# HISTORIC AND DESIGN REVIEW COMMISSION

August 04, 2021

**HDRC CASE NO:** 2021-350  
**ADDRESS:** 407 E EVERGREEN  
**LEGAL DESCRIPTION:** NCB 396 BLK 29 LOT 8  
**ZONING:** MF-33,H  
**CITY COUNCIL DIST.:** 1  
**DISTRICT:** Tobin Hill Historic District  
**APPLICANT:** MARK SALVADOR/FISHER HECK ARCHITECTS  
**OWNER:** ROSEN RANDALL A & CYNTHIA E  
**TYPE OF WORK:** Construction of two, 1-story rear accessory structures, exterior modifications  
**APPLICATION RECEIVED:** July 12, 2021  
**60-DAY REVIEW:** Not applicable due to City Council Emergency Orders  
**CASE MANAGER:** Stephanie Phillips  
**REQUEST:**

1 GARAGE EAST ELEVATION  
3/8" = 1'-0"

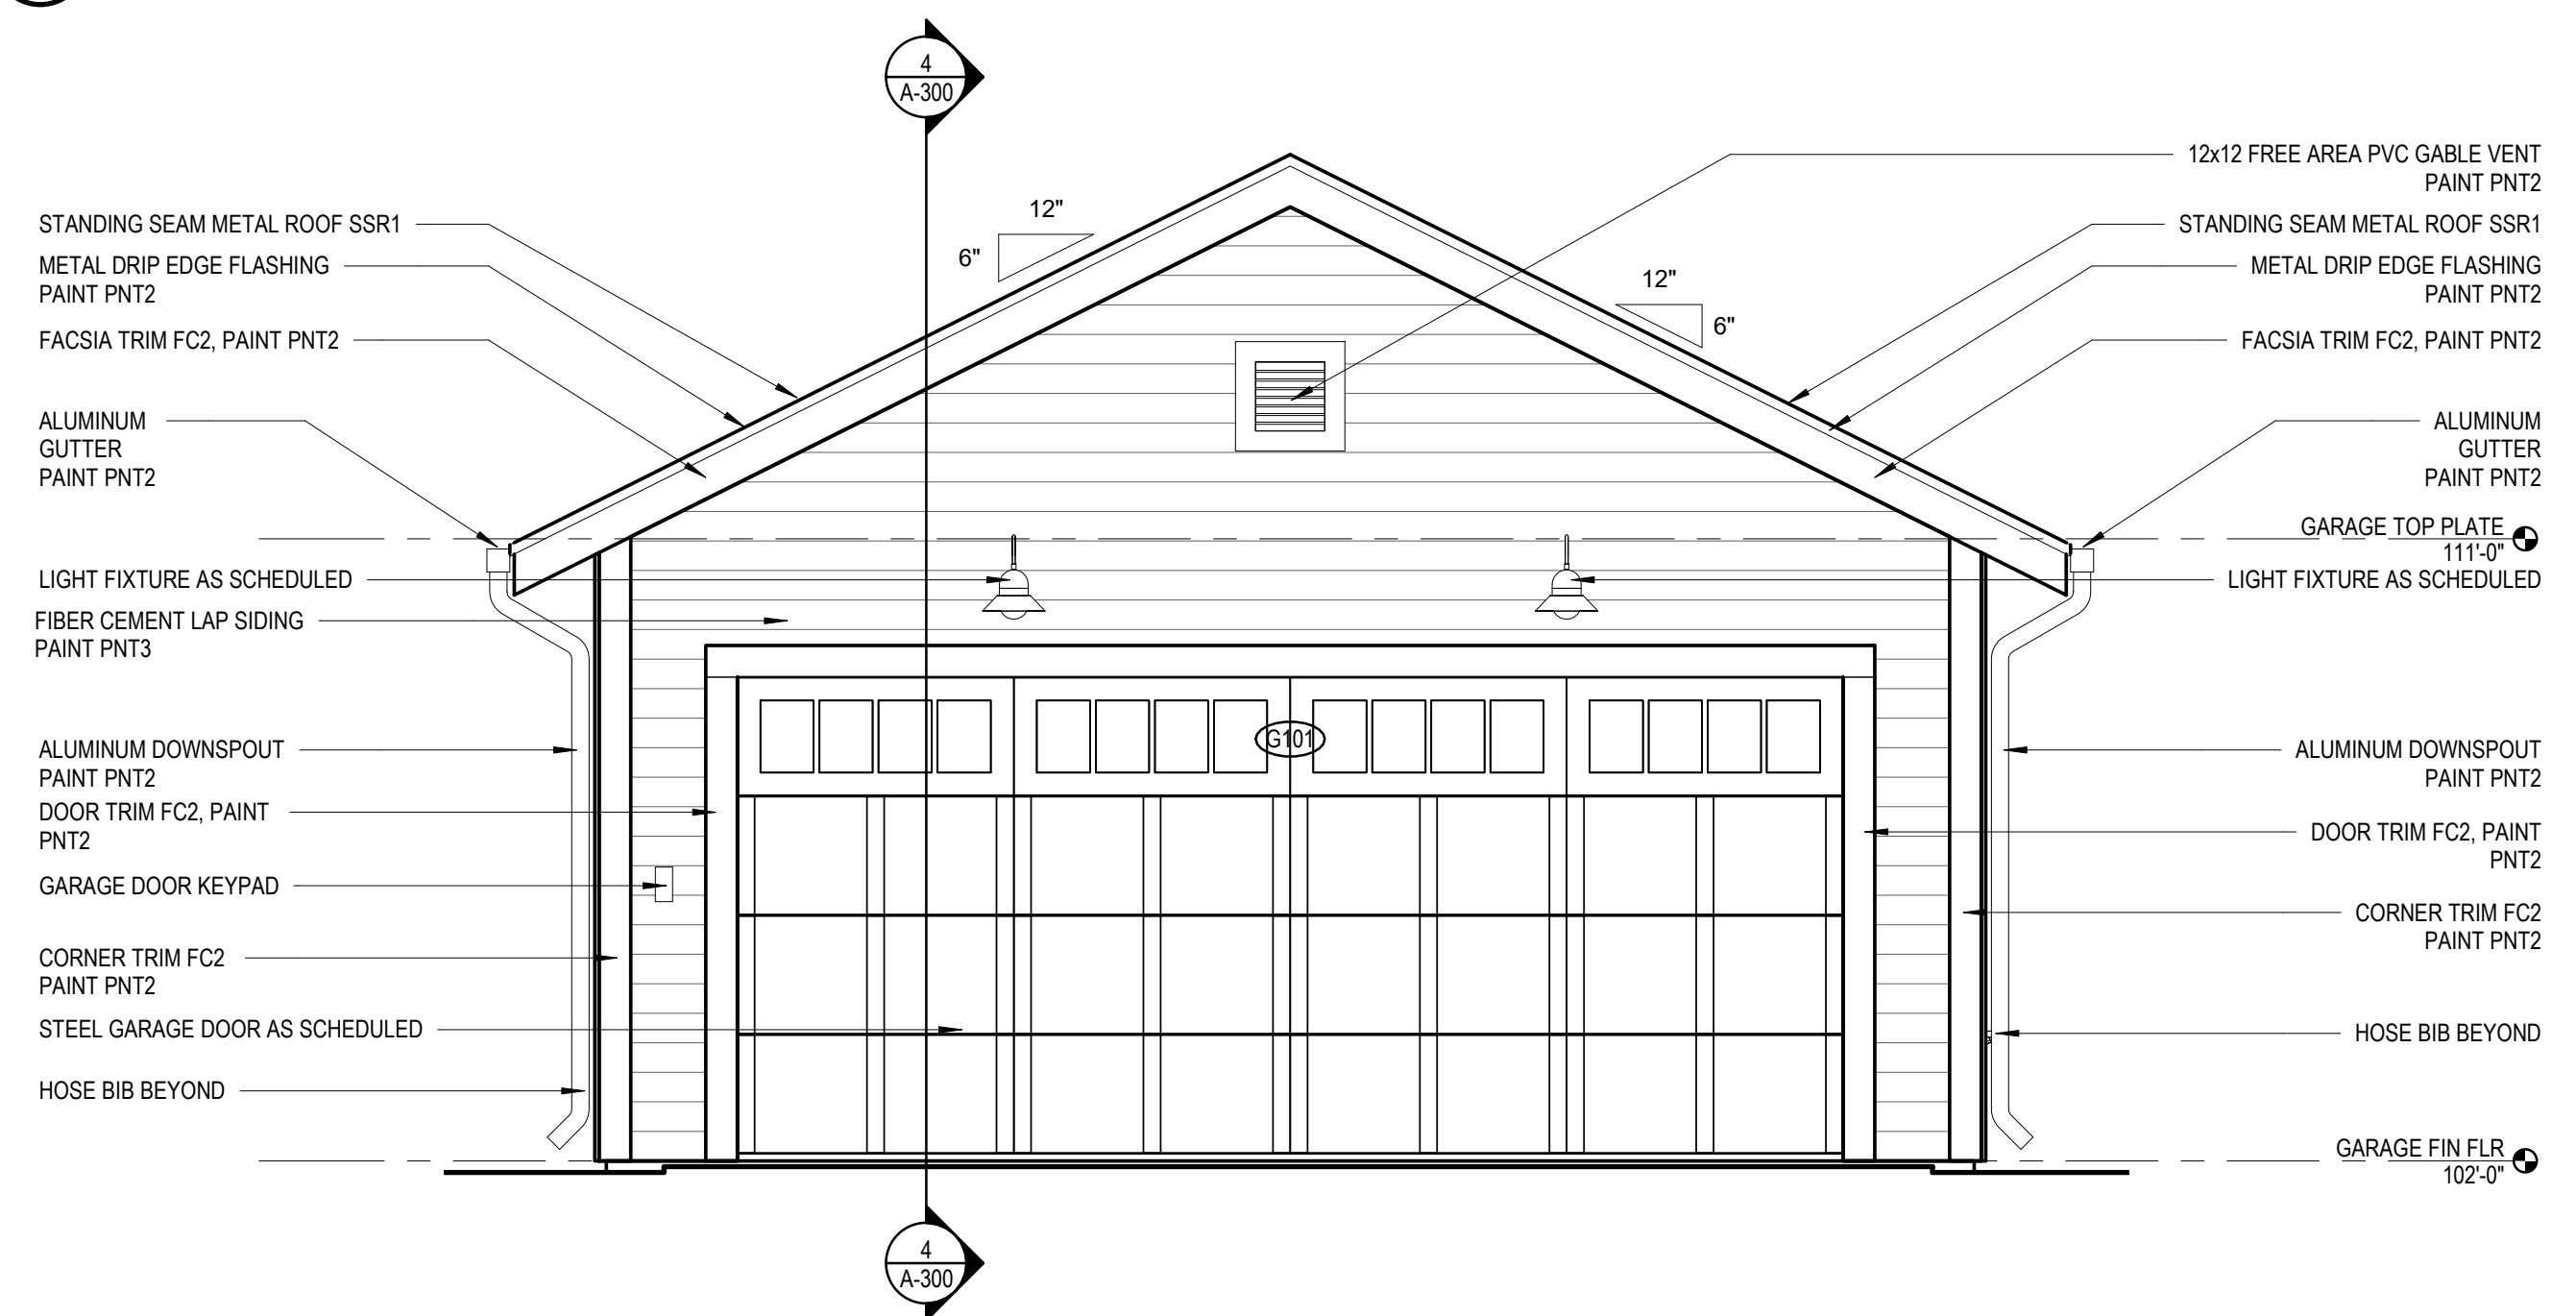
- e. **FENESTRATION** – According to the Historic Design Guidelines, openings in new construction should use traditional dimensions and profiles found on the primary structure or within the historic district. Based on the submitted elevations, the applicant has proposed one over one windows and door configurations that are consistent with historic patterns. The applicant has also proposed a double-width garage door. Staff generally finds the window patterns and pedestrian doors appropriate with the stipulations listed in the recommendation, but finds that the applicant should install two single-bay garage doors in lieu of the proposed double-width garage door to be more consistent with the Guidelines.

- i. That the applicant installs two single bay garage doors in lieu of the proposed double width overhead door as noted in finding g.
- ii. That the applicant installs a fully wood or aluminum clad wood window that meet staff's standard window stipulations and submits updated specifications to staff for review and approval. The windows should feature an inset of two (2) inches within facades and should feature profiles that are found historically within the immediate vicinity. Meeting rails must be no taller than 1.25" and stiles no wider than 2.25". White manufacturer's color is not allowed, and color selection must be presented to staff. There should be a minimum of two inches in depth between the front face of the window trim and the front face of the top window sash. This must be accomplished by recessing the window sufficiently within the opening or with the installation of additional window trim to add thickness. Window trim must feature traditional dimensions and architecturally appropriate sill detail. Window track components must be painted to match the window trim or concealed by a wood window screen set within the opening. All paired windows should feature a true ganged condition as noted in finding e.
